Access Compliance Report

Public Rights-of-Way

(Curb Ramps)

Intersection ID: 53160	Main Street: PERTH_MOOR_RD	Cross Street: HAMILTON_BRIDGE_RD	Location: NW
ADA ID: 6095F4F075BA	Ramp Type: Perp	Initial Pass/Fail: Fail	Overall Compliance: No
Severity Score: 22.5			
Codes/Mitigation Info/Possible Solution		Field Measurements/Component Compliance

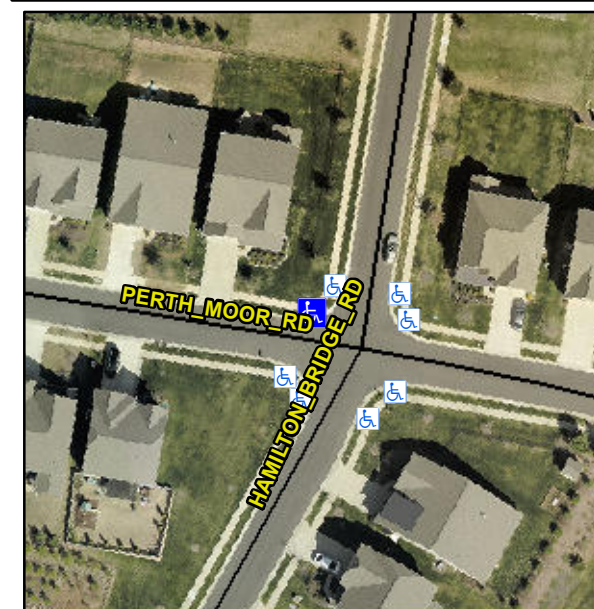
Not Found, R304.5.1, R304.2.2, R304.5.3

Compliance	Description	Data	Compliance	Description	Data
N/A	Ramp Length (in)	49.0	No	Ramp Slope (%)	10.8
No	Ramp Width (in)	46.5	No	Ramp XSlope (%)	4.2
N/A	Flare Type LT	N/A	N/A	Flare Type RT	N/A
N/A	Flare Slope LT (%)	N/A	N/A	Flare Slope RT (%)	N/A
N/A	Flare Traversable LT?	N/A	N/A	Flare Traversable RT?	N/A
N/A	Landing Length (in)	N/A	N/A	DWS Provided?	N/A
N/A	Landing Width (in)	N/A	N/A	DWS Contrast?	N/A
N/A	Landing Slope (%)	N/A	N/A	DWS Length (in)	N/A
N/A	Landing X Slope (%)	N/A	N/A	DWS Full Width?	N/A
N/A	Landing Curb? (Y/N)	N/A	N/A	DWS Offset (in)	N/A
N/A	Shared Landing?	N/A			
N/A	Gutter Ponding?	N/A	N/A	Gutter Slope (%)	N/A
N/A	Gutter Lip Ht (in)	1.5	N/A	Gutter X Slope (%)	N/A
N/A	Painted X Walk1?	No	N/A	Painted X Walk2?	N/A
	X Walk 1 Direction	To SW		X Walk 2 Direction	N/A
N/A	X Walk 1 Width (in)	N/A	N/A	X Walk 2 Width (in)	N/A
	X Walk 1 Slope (%)	2.7		X Walk 2 Slope (%)	N/A
	X Walk 1 X Slope (%)	2.4		X Walk 2 X Slope (%)	N/A

Remove & Replace Entire Ramp.
